**TYPE III**  
**STAFF REPORT AND RECOMMENDATION**  
*June 20, 2019*

**FILE NUMBER:** GLUA-19-00011 (General Land Use Application), CI-19-00001 (Code Interpretation), CU-19-00001 (Conditional Use) SP-19-00037 (Site Plan and Design Review), VAR-19-00002 and VAR-19-00003 (Variances)

**REQUEST:** The applicant requests a Code Interpretation and Conditional Use to construct a new 33,000 square foot one story building to house the Police Station and Municipal Court/Commission Chambers, along with associated parking lots and a public plaza. The application includes Site Plan and Design Review and two Variance requests for building placement and building design. Approval of the demolition of the existing Mt. Pleasant school building has been granted through a separate review.

Figure 4: Proposed Building Elevations

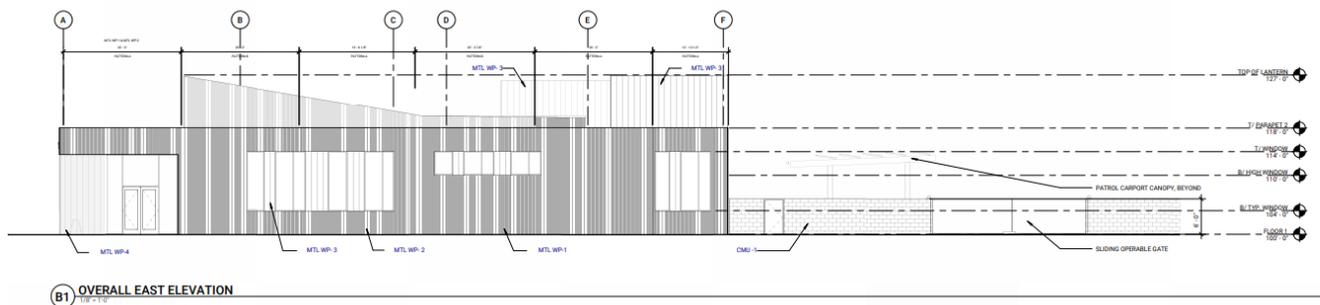
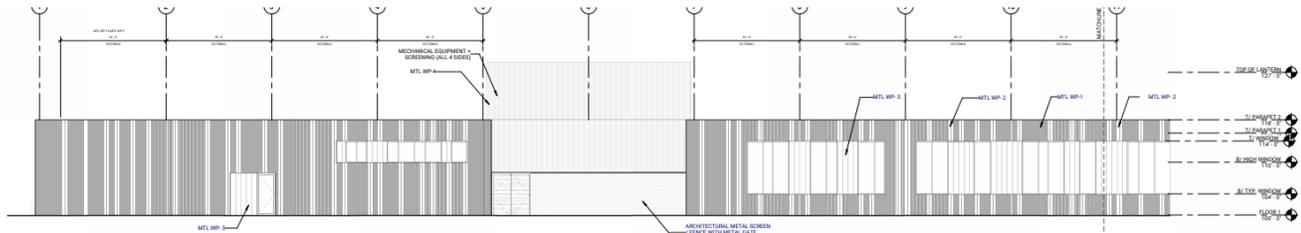
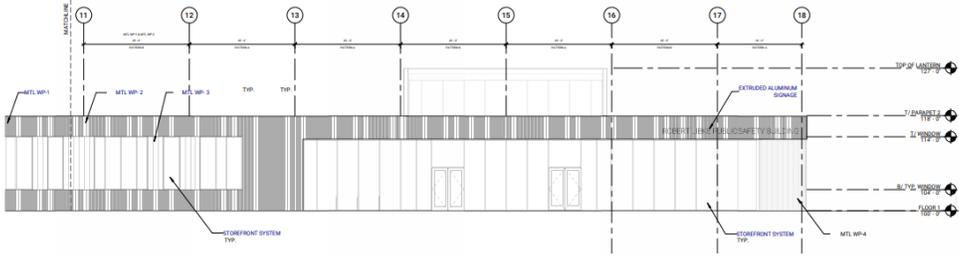
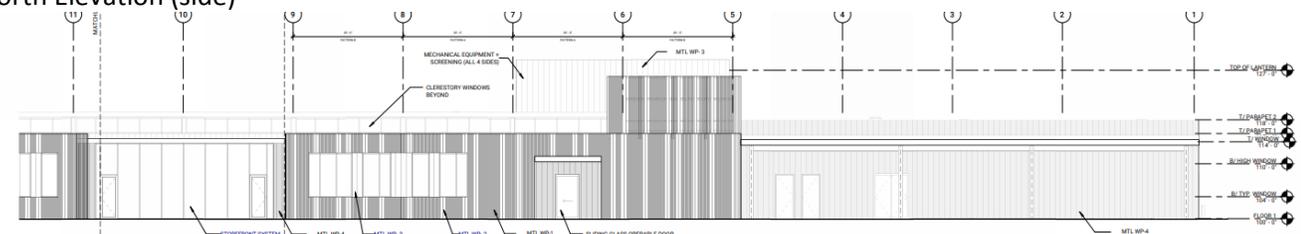
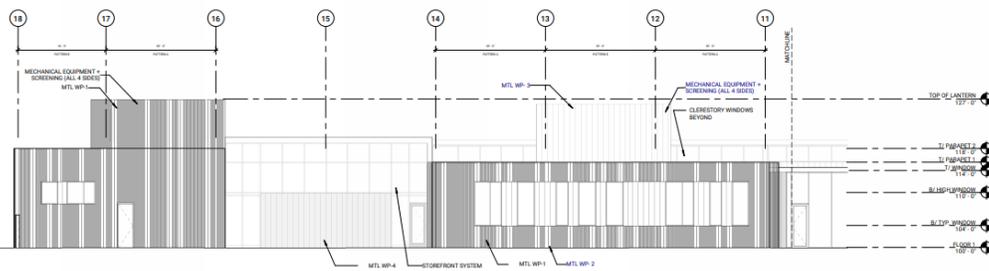
The south façade lacks wall plane projections or recessions for 123 feet of wall length. The east façade, which faces Linn Avenue, has a wall plane recession that extends less than 20% of the length of the façade. The east façade, which is the front of the building facing Linn Avenue, contains 31% transparency at the pedestrian level, which is less than the required 60%. The applicant explains that “because of the nature of the building, security measures and the type of rooms next to the Linn Avenue street frontage (restrooms and jury rooms fewer windows are required in an effort to preserve the sense of privacy and security that is needed in the building.

Code requires wall plane modulation for facades over 100 feet in length. The south façade lacks wall plane projections or recessions for 123 feet of wall length.

The east façade, which faces Linn Avenue, has a wall plane recession that extends less than the required 20% of the length of the façade. The façade is 113 feet in length and has a recession of 20 feet in length, which is 17.7%.

3. The applicant shall increase the window transparency on the front façade as much as possible by adjusting the conference room windows to the pedestrian level and reducing the length of the metal wall panels in between windows, in order to minimize the required variance.

4. The applicant shall add a form of architectural interest to all sections of blank wall that are longer than 30 feet.
5. The applicant shall provide additional hard surface space to meet Trimet’s needs for a bench and shall coordinate with Trimet to implement the bus stop relocation.
